**Responses to NRC Letter Dated August 19, 1997 and December 5, 1997, Regarding NRC
Acceptance Review of the Reclamation Plan for the White Mesa Uranium Mill**

**Source Material License SUA-1358
Docket No. 40-8681**

**Response to Nuclear Regulatory Commission / White Mesa Mill Reclamation Plan
Comments Dated August 19, 1997
Source Material License SUA-1358**

**Response to Nuclear Regulatory Commission / White Mesa Mill Reclamation Plan
Comments Received December 8, 1997
Source Material License SUA-1358**

Cell 2 Settlement Monitors

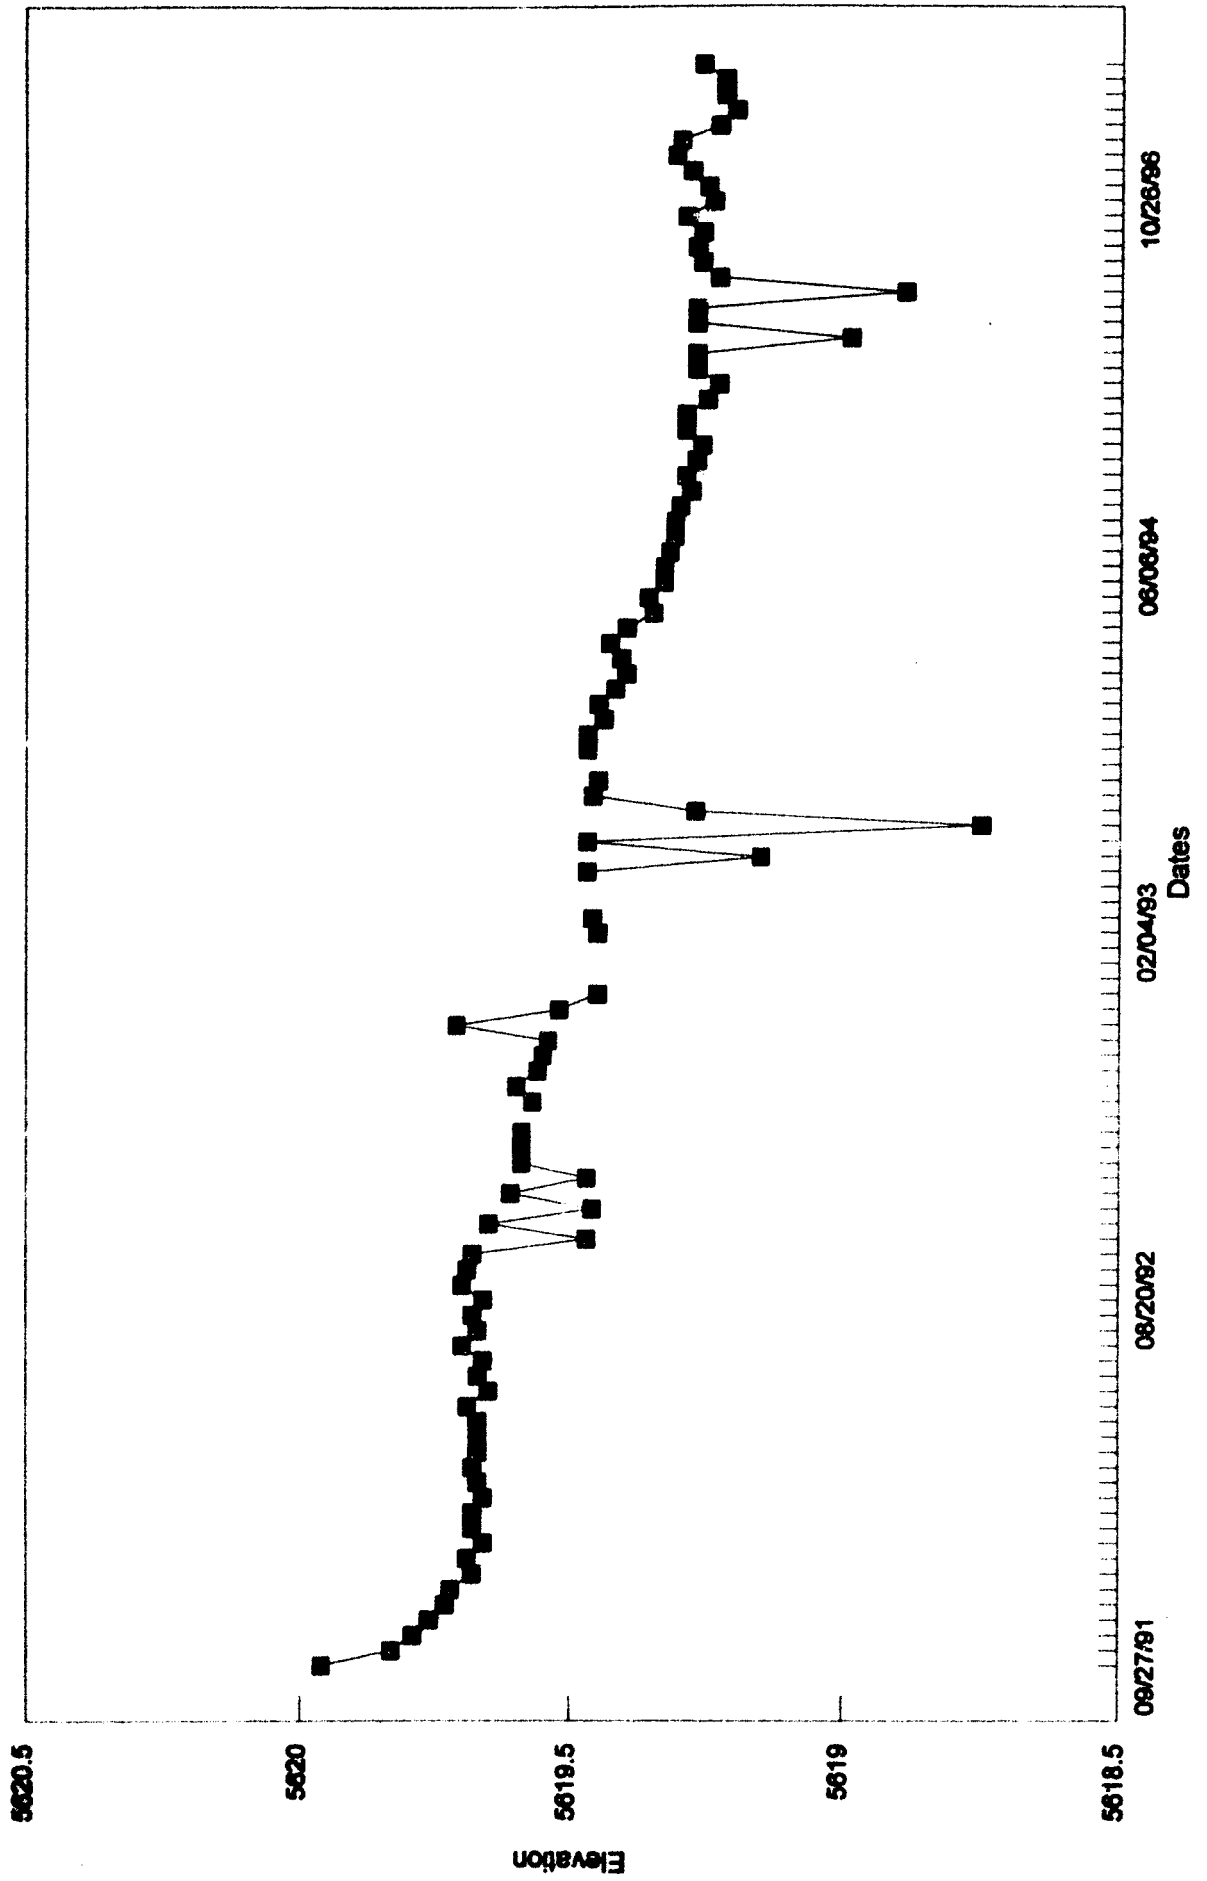
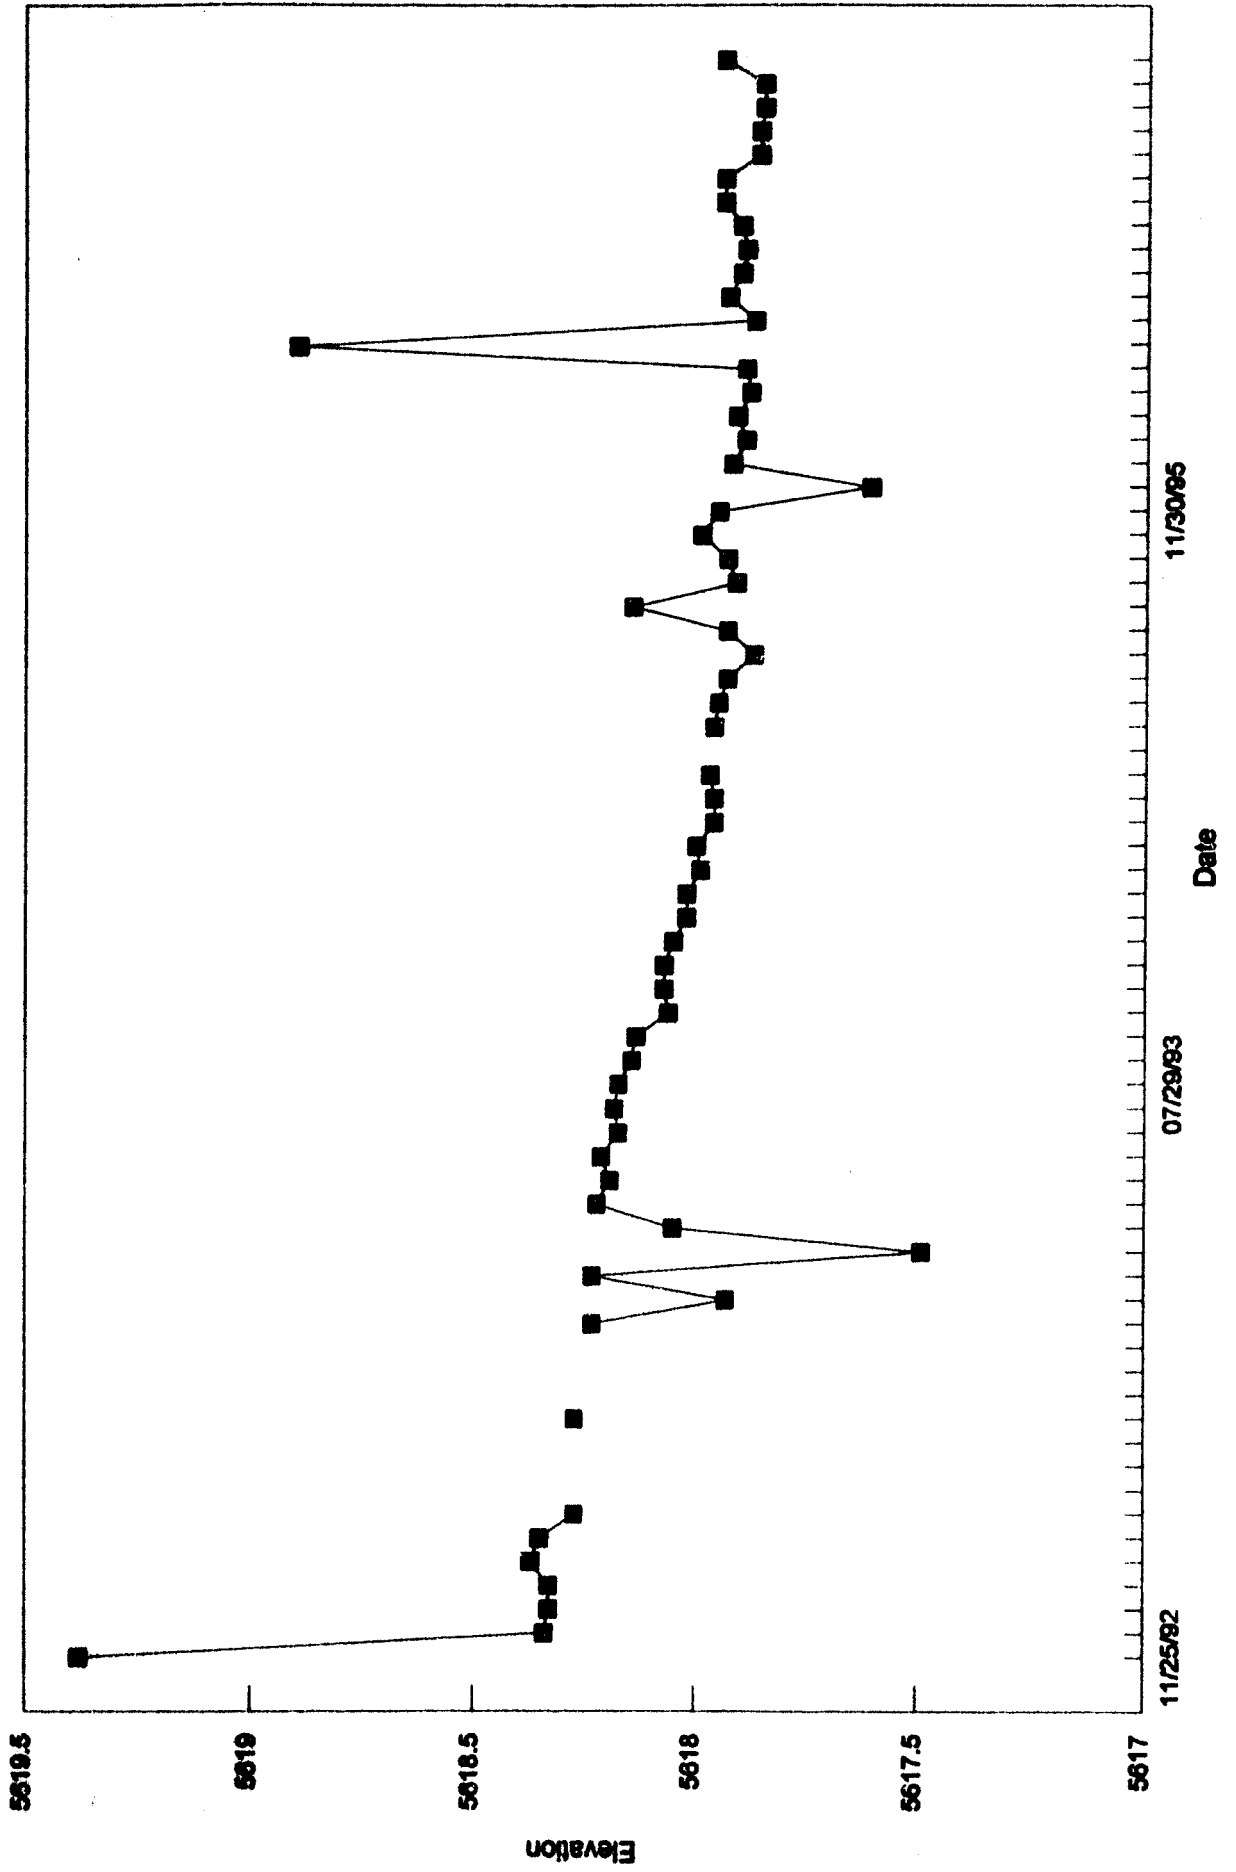
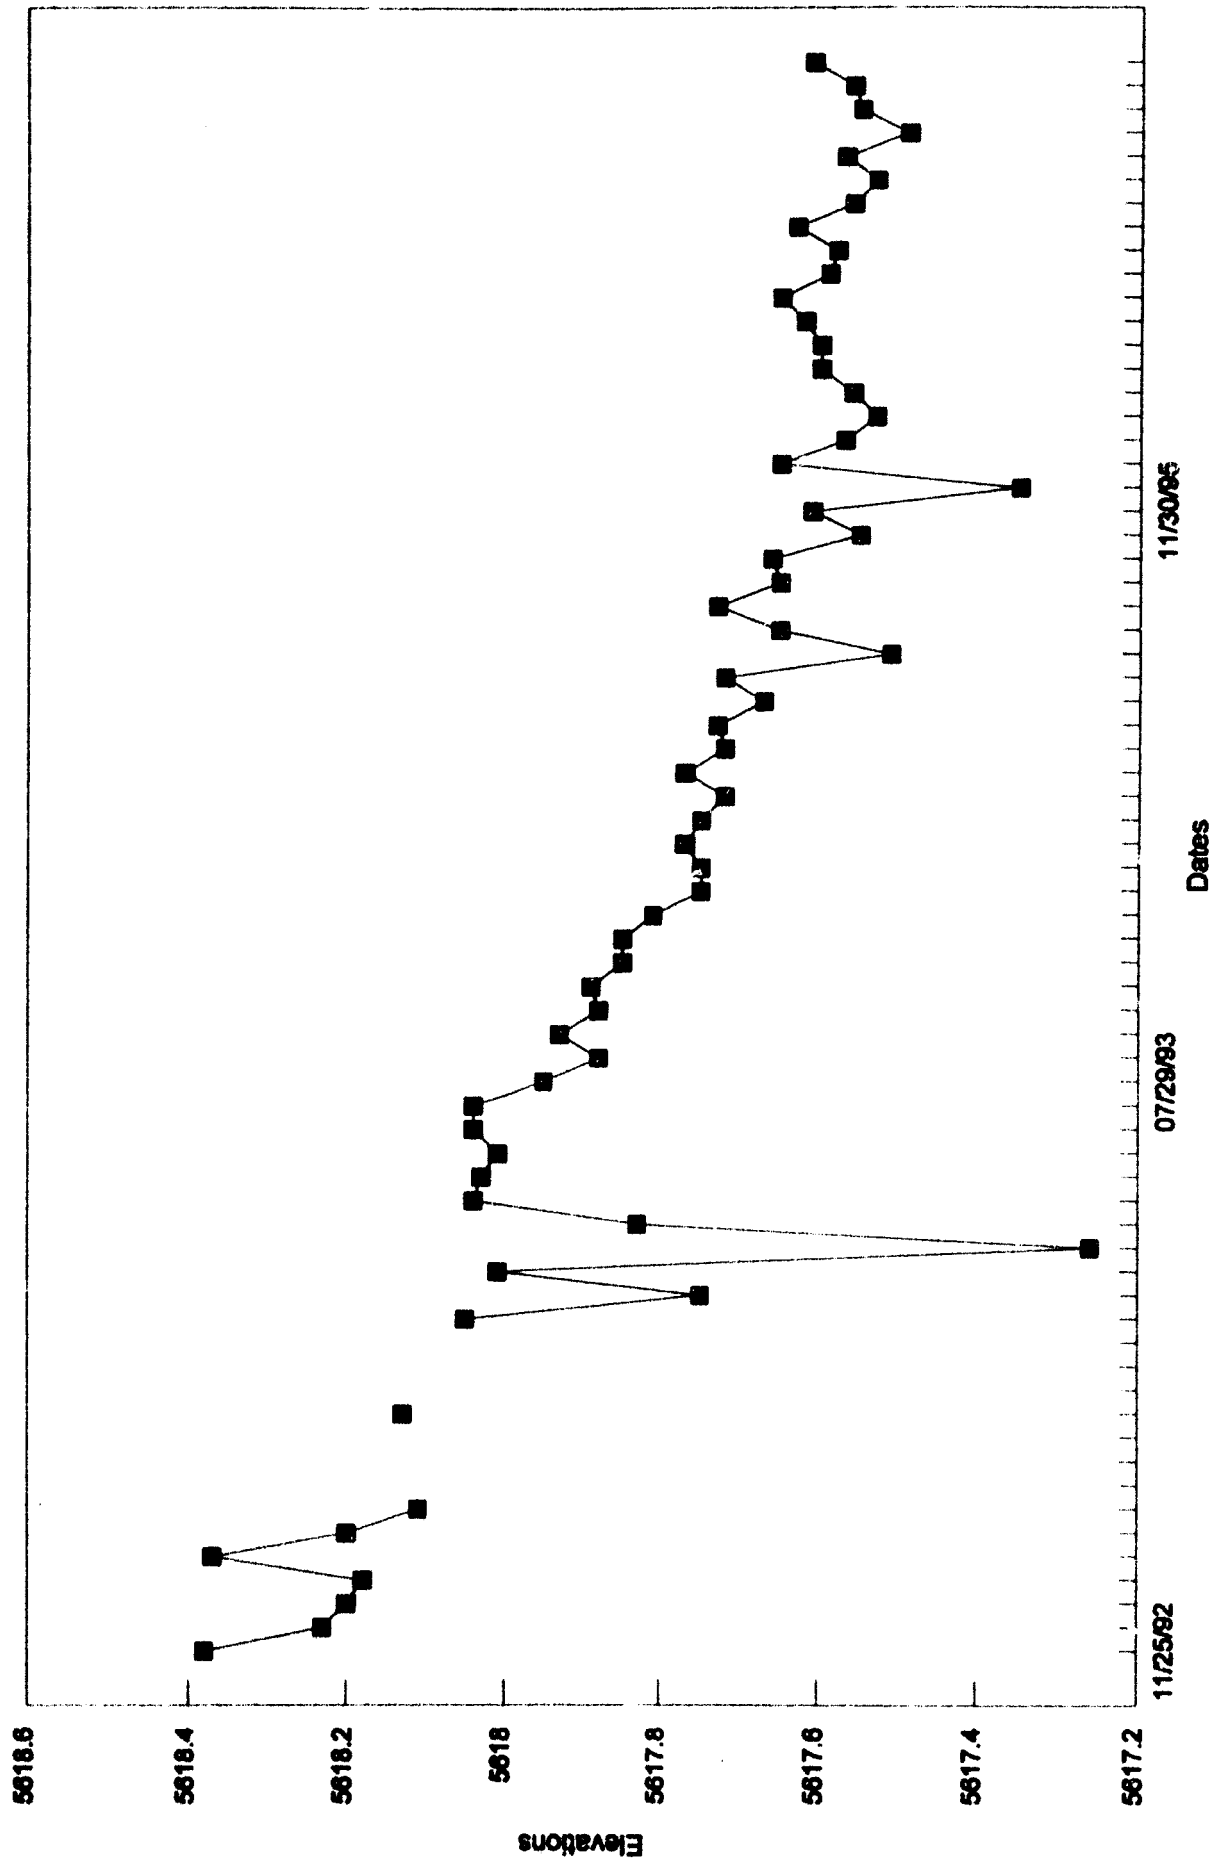
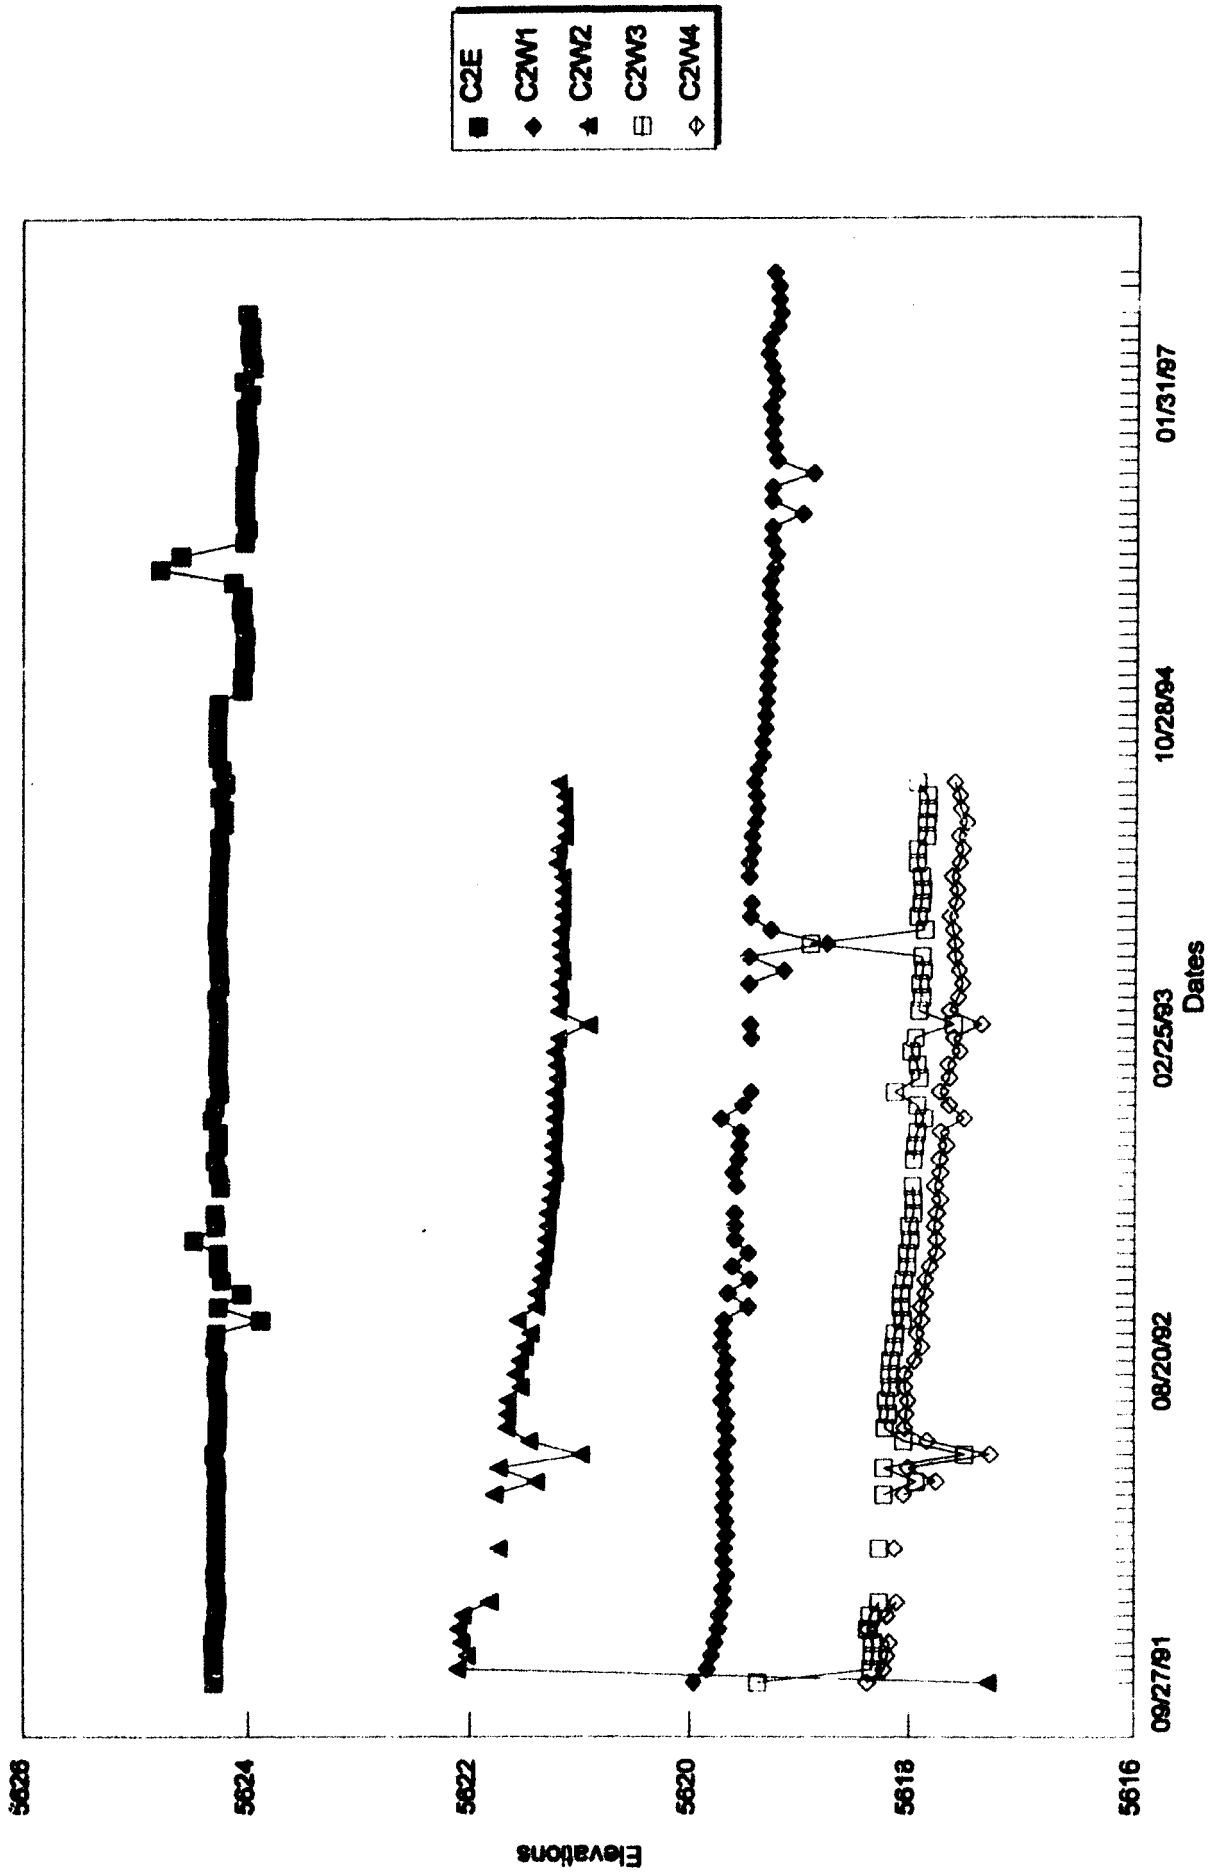
(2) An analysis of the total and differential settlements of the tailings surface and the effects of such settlements on soil cover integrity.

Analysis of the total and differential settlement of the tailings surface was performed using the survey data compiled for the five settlement monuments installed within Cell 2. These monuments were installed on the surface of the tailings, between August 1989 and November 1992, prior to the placement of approximately three to four feet of random fill material. Survey results of each monument were plotted as time vs. settlement graphs and are presented in Attachment 2 of this response.

Review of the survey data and graphs shows that primary consolidation of the tailings has occurred, and the settlement rate has been very slow with minor total values. The maximum total settlement recorded is 0.97 feet, and the differential settlement is on the order of 0.50 feet. Approximately 81 percent of the total measured settlement occurred within the initial three years. Additionally, recent survey data indicates that the settlement has virtually stopped. From September 1995 to September 1997 the settlement averaged less than 0.03 feet per year, which is within the expectable survey error of 0.05 feet. This indicates that the settlement since 1995 is negligible.

Placement of the final reclamation cover will induce additional settlement. However, since primary consolidation of the tailings has occurred, under current loading conditions, additional settlement is expected to be less than the total settlement values to date. This minor amount of additional settlement, due to the added surcharge of the cap, will not effect the integrity of the six foot thick final reclamation cover.

9801090276-04
FIGURE 1

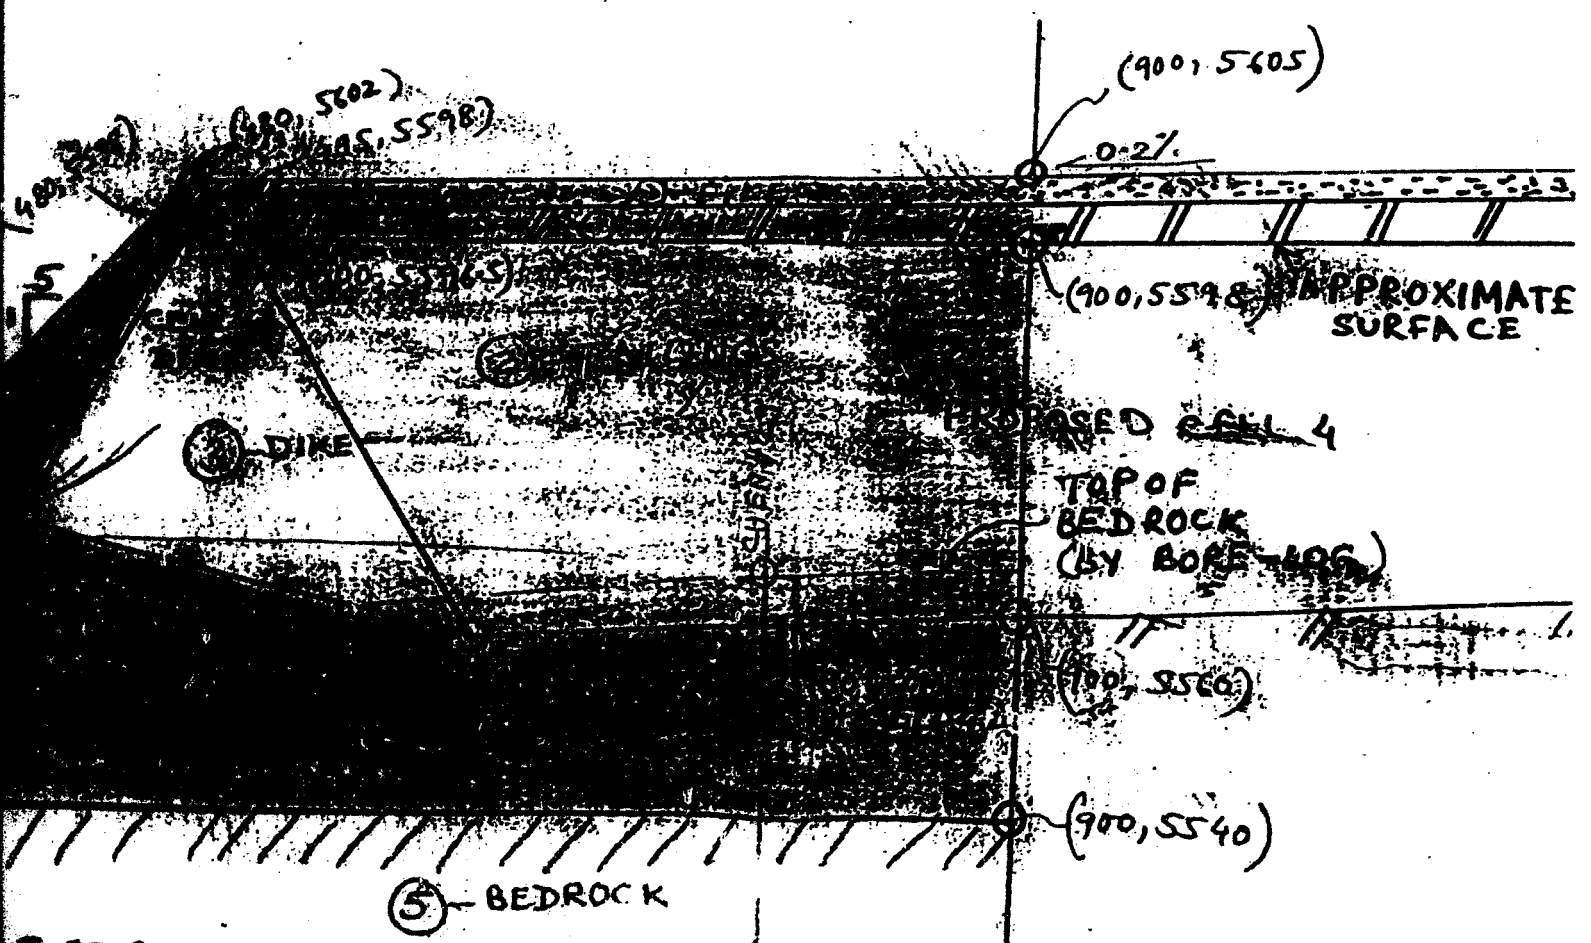
(11) A replacement of seven pages of illegible data. These pages are in appendix A of Appendix D [Tailings Cover Design White Mesa Mill, October 1996 (pages marked p. 12 through p. 17)] and in appendix G of Appendix D [Tailings Cover Design White Mesa Mill, October 1996 (figure showing cross-section along Cell 4 dike)].

The seven replacement pages are included in Attachment 3 of this response.
